**PROJECT NAME: Oyu Tolgoi Underground Project
Rev_1**

REQUEST FOR INFORMATION (RFI)			
TO:	Jacobs	DATE:	06-12-2022
FROM:	MCS International LLC	RFI No:	TWS-0414-RFI-0024
PHONE #:	+976-77226262	REV #	0
SUBJECT: Road train bay 1 & 2: Maintenance pit lifting point and packer's dimension			
Reference Document No.	Rev No.	Title	
1883-55-L4-8768	4	SUPPORT / HOLD DOWN DIAGRAM (DETAILS) INCLUDING LOADS & FORCES	
1883-55-L4-8771	2	ERCTION INSTRUCTIONS	
Discipline Codes (Mandatory)	D1 (CSA) - <input type="checkbox"/>	D2 (MP) - <input checked="" type="checkbox"/>	D3 (E&I) - <input type="checkbox"/> D4 (Other) - <input type="checkbox"/>
<u>Request:</u>			
<p>The Contractor requests the Company to clarify following information.</p> <ol style="list-style-type: none"> 1. The two dimensions of between packer top and TOC (FFL) are different in drawings 1883-55-L4-8768 and 1883-55-L4-8771. Witch dimension is correct. (Attachment 1) 2. In drawing 1883-55-L4-8768, L1 to L8 lifting points locations and WLL are unclear. (Attachment 2)

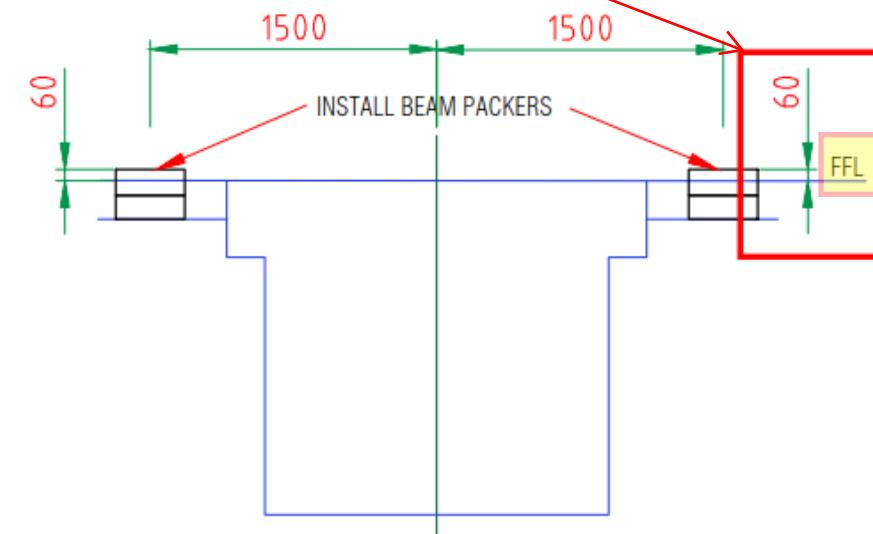
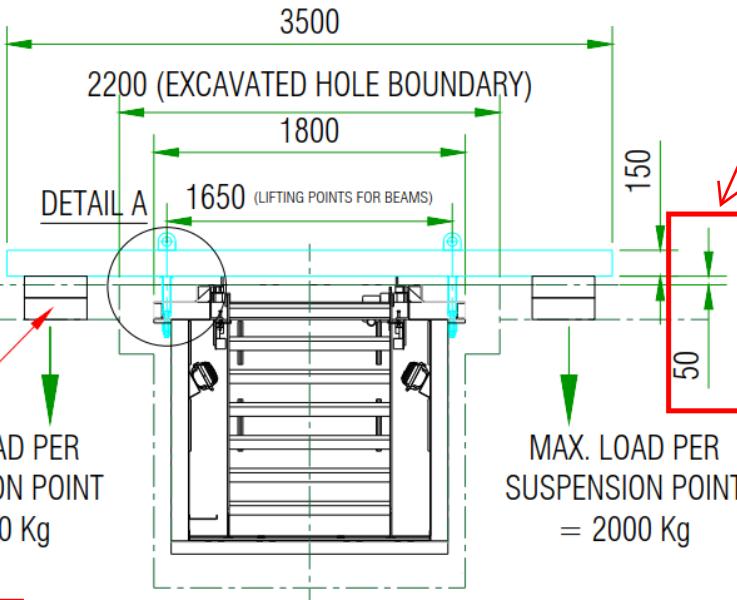
The two dimensions are different in drawings 1883-55-L4-8768 and 1883-55-L4-8771. Which dimension is correct.

1883-55-L4-8768

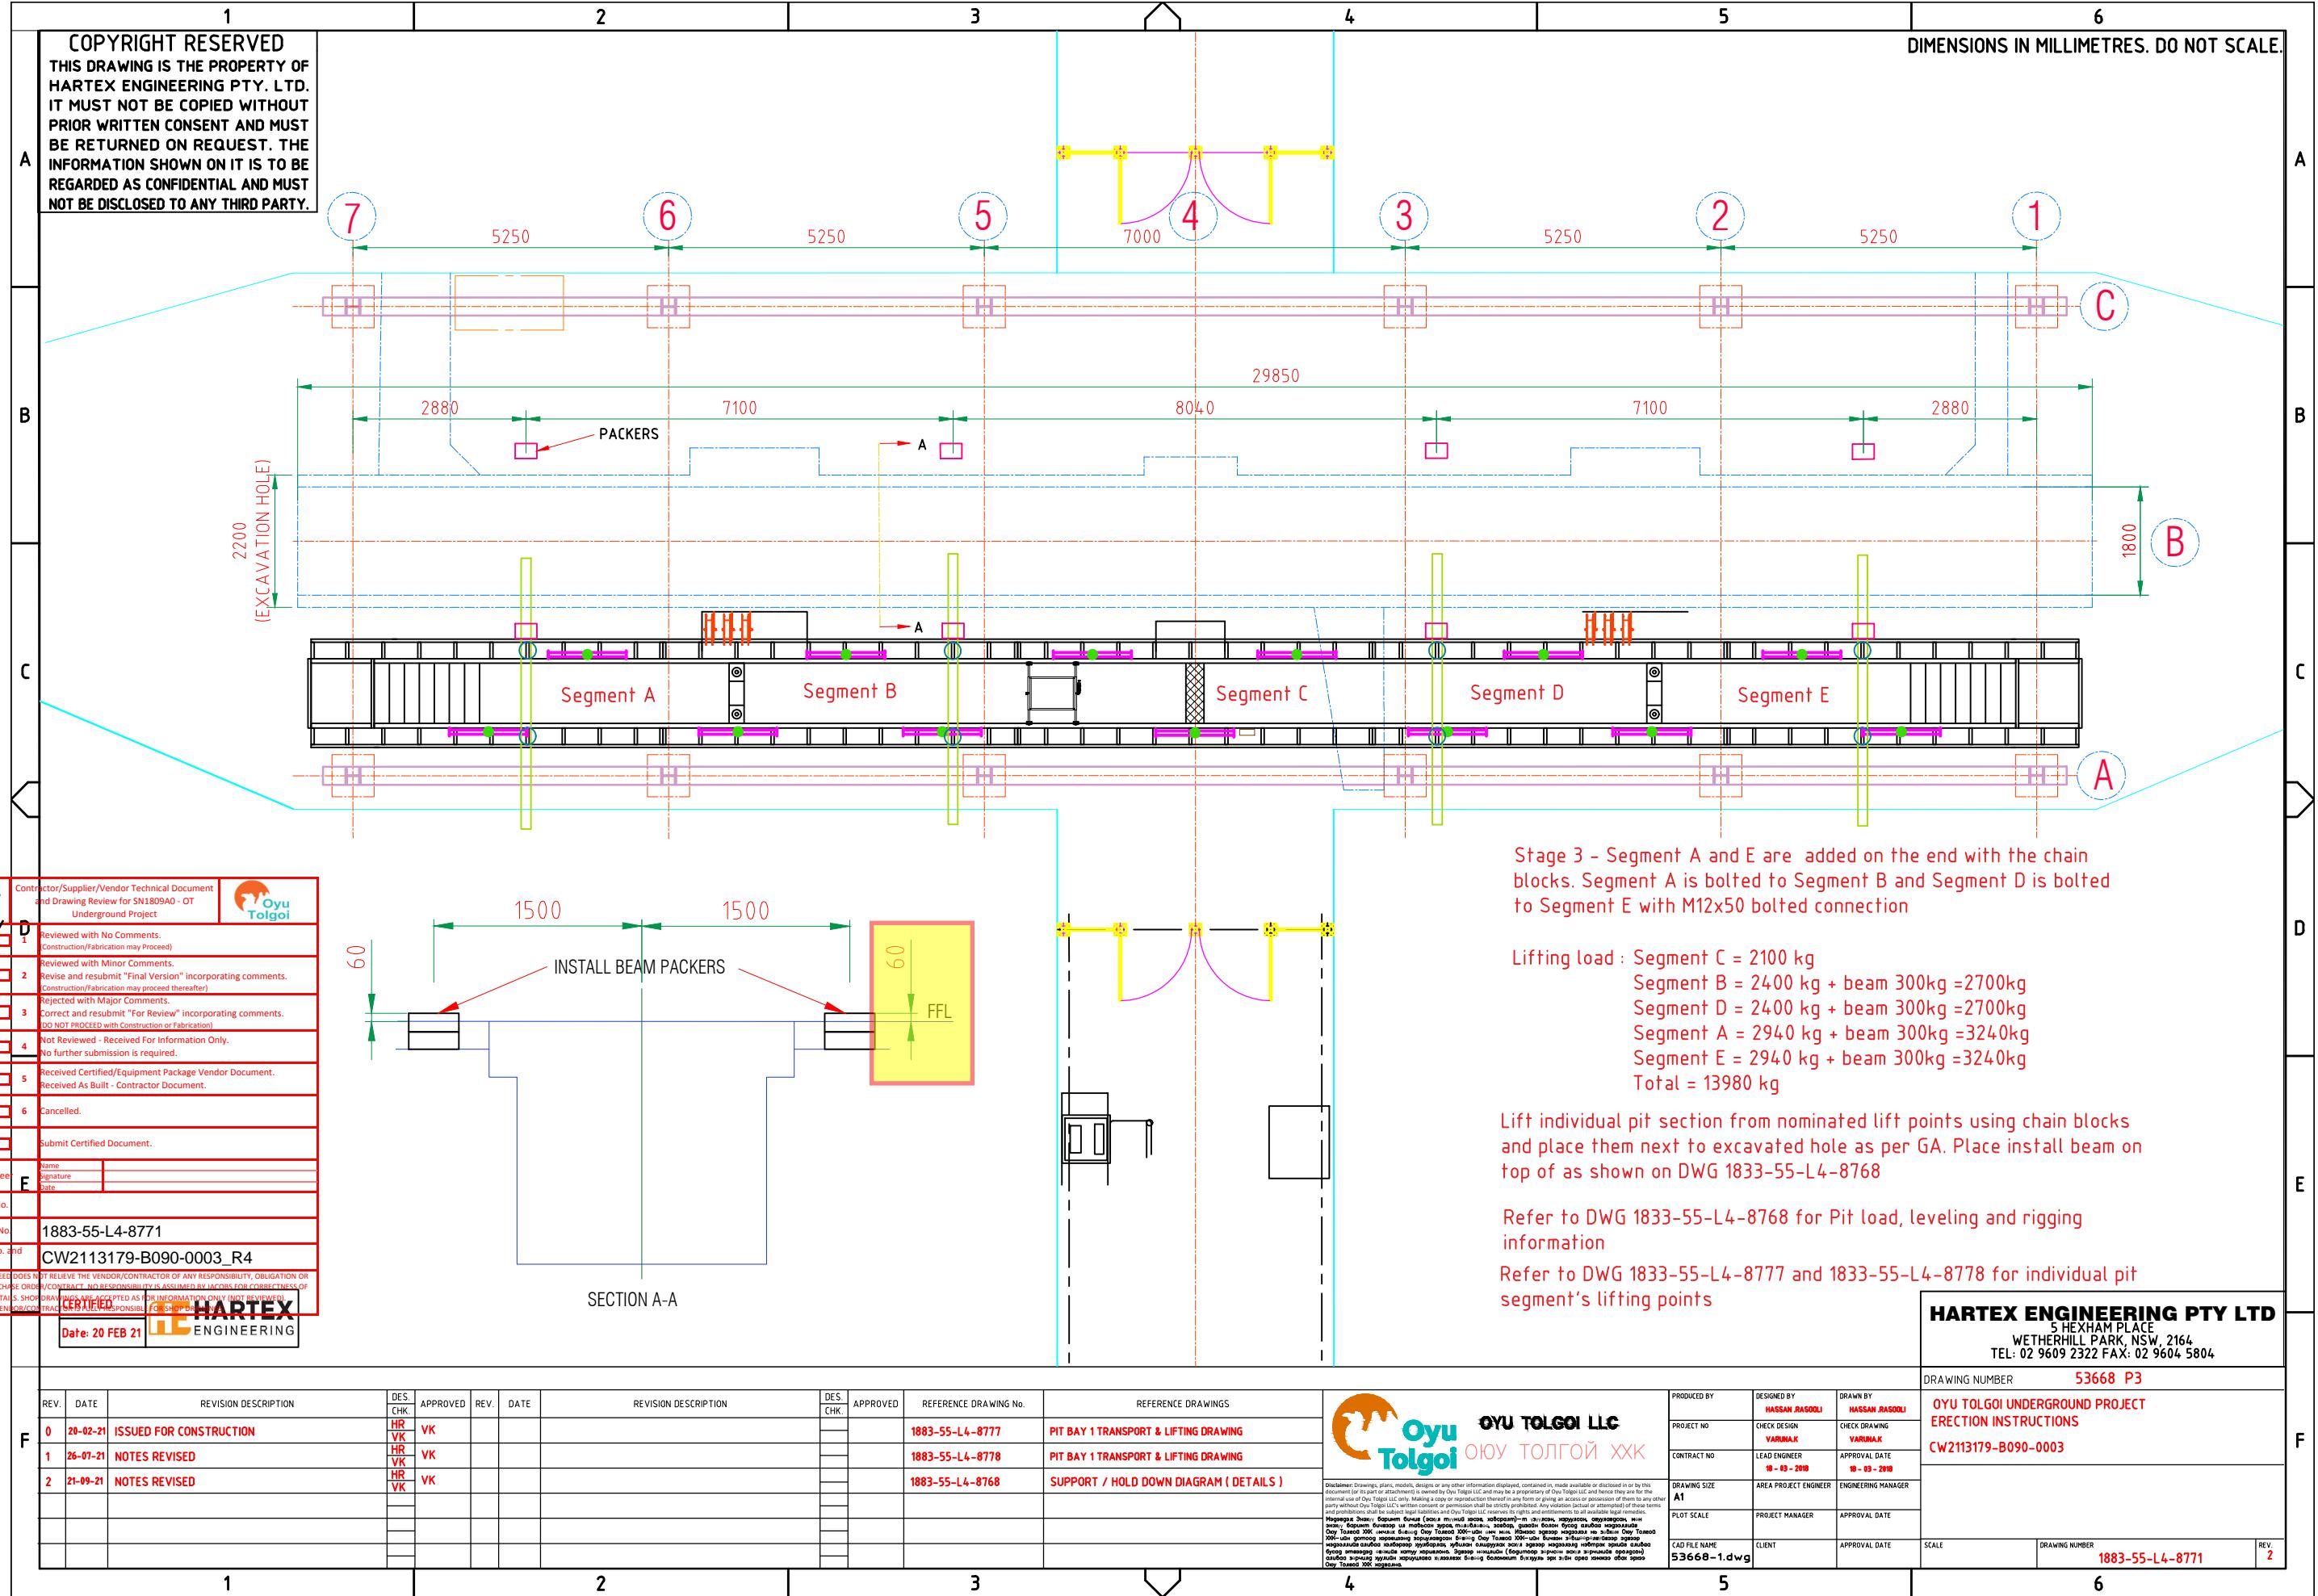
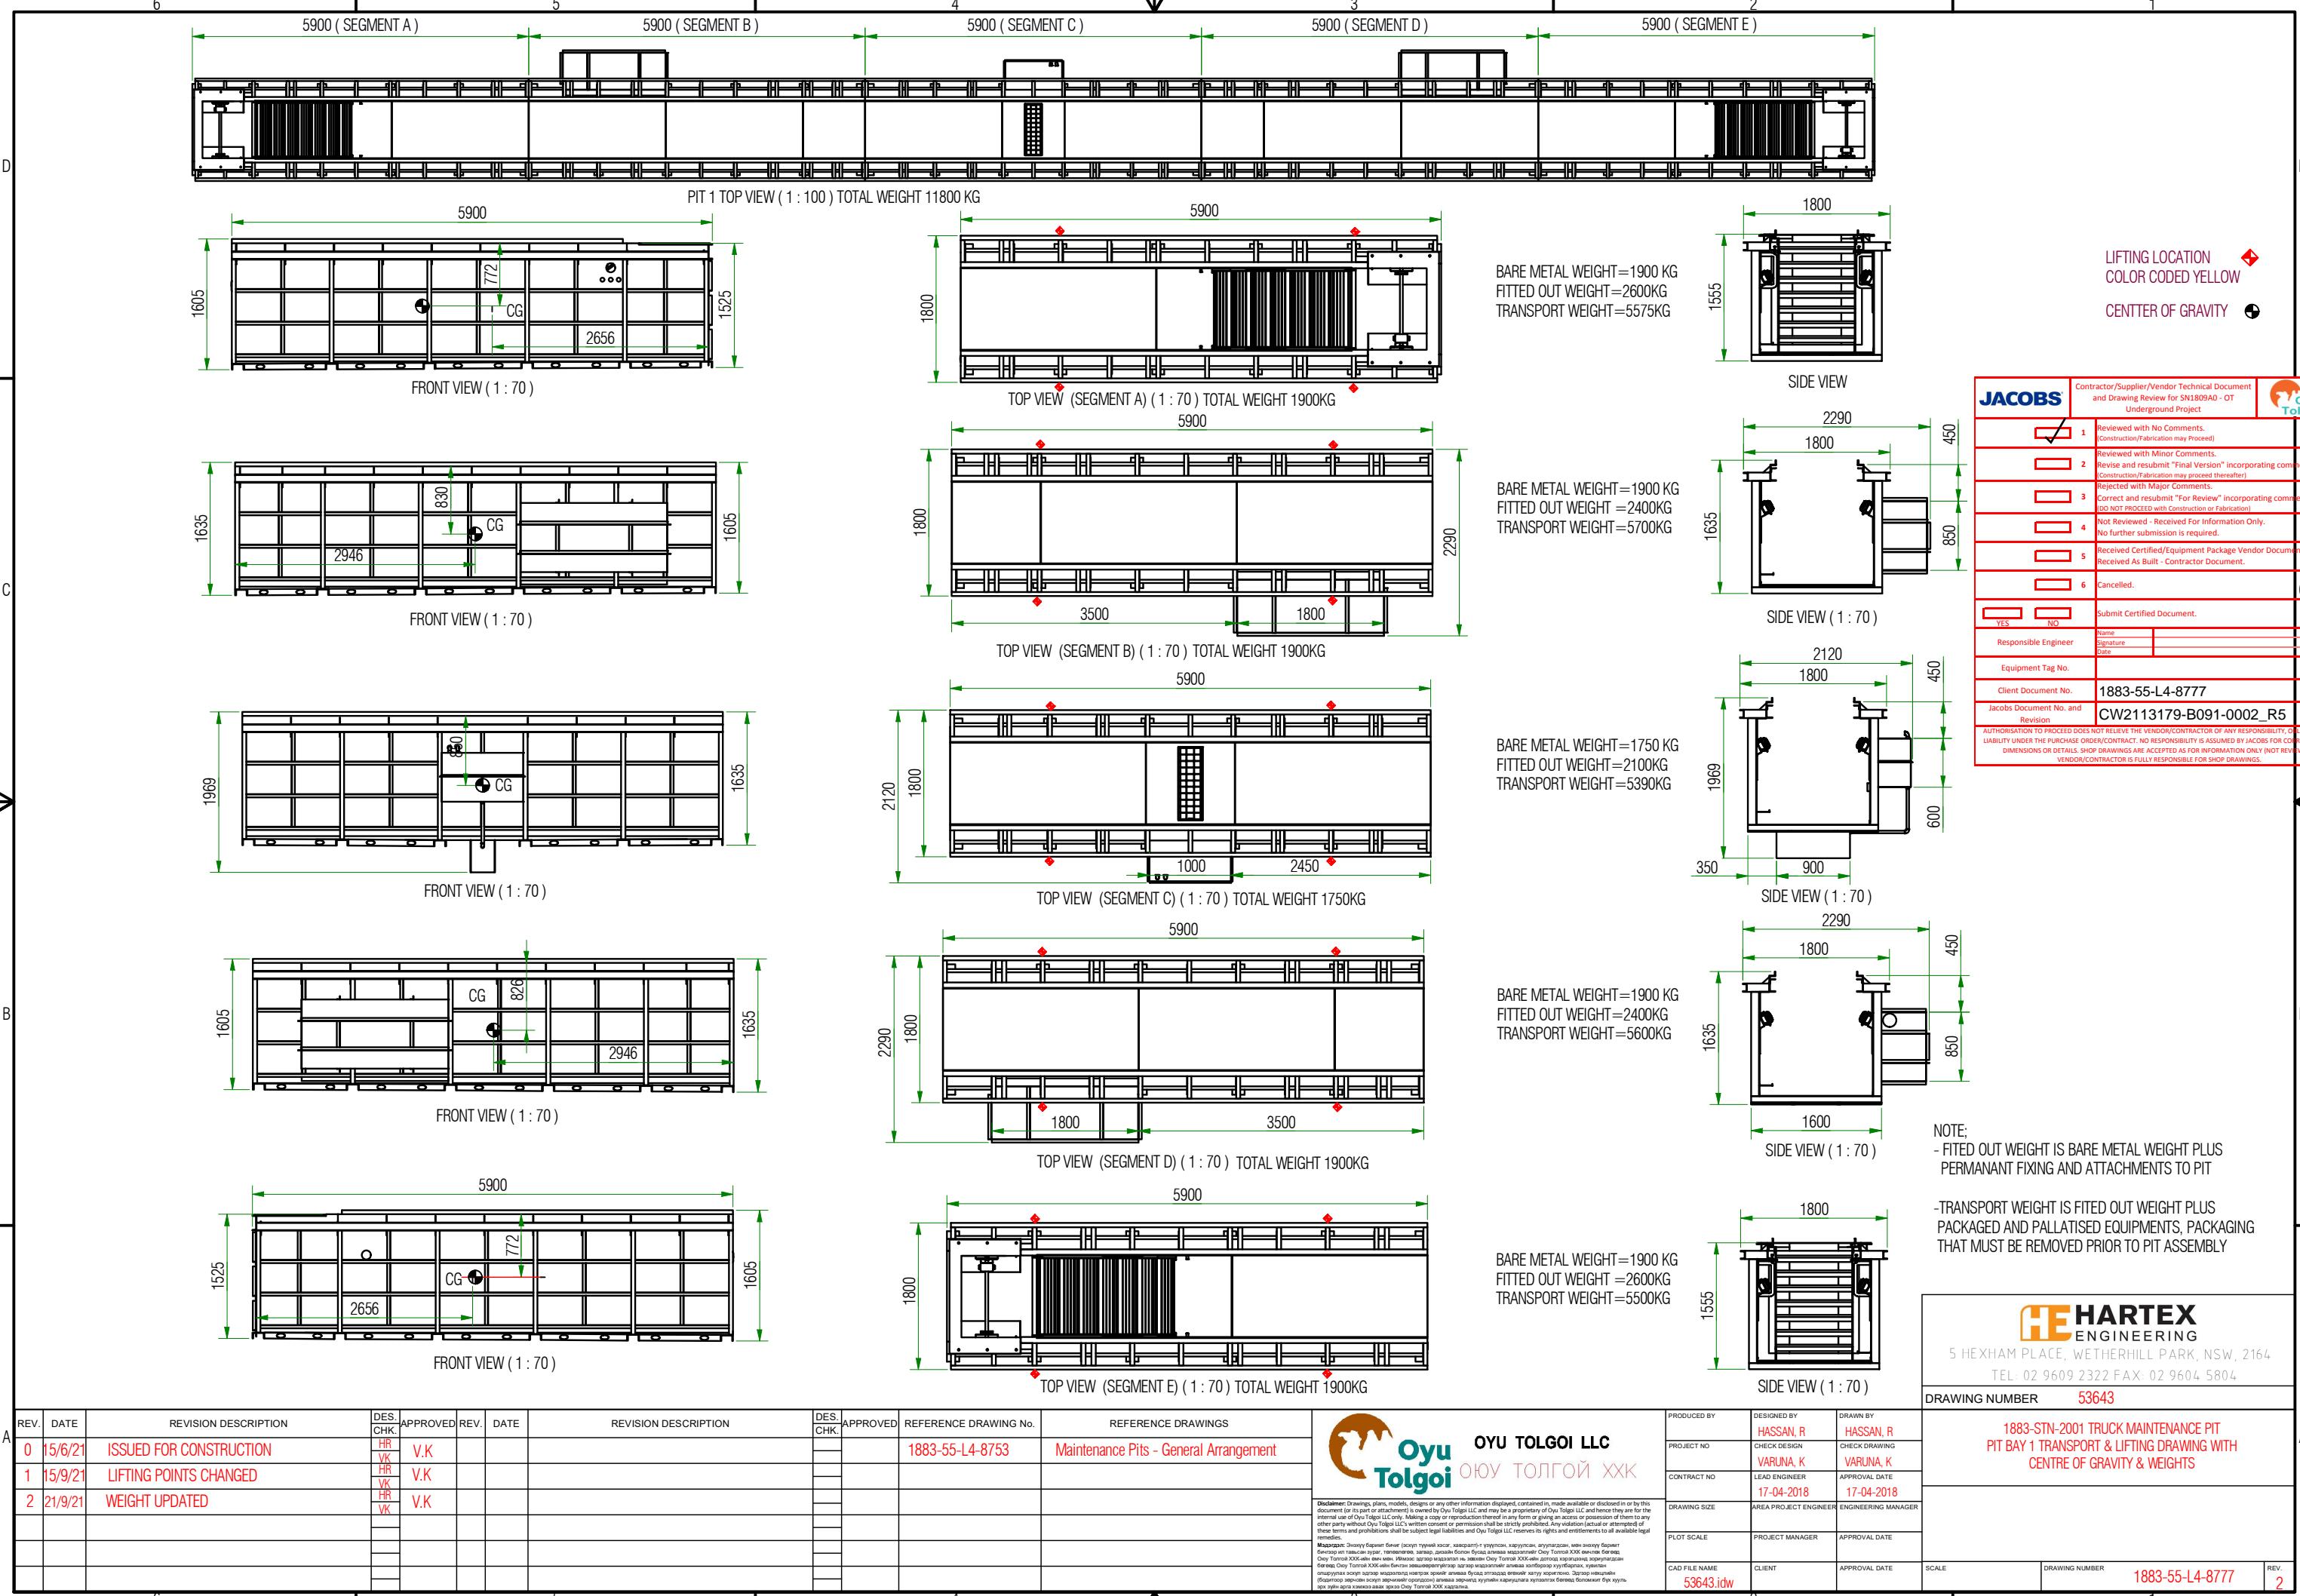
L1 to L8 lifting points locations and WLL are unclear.
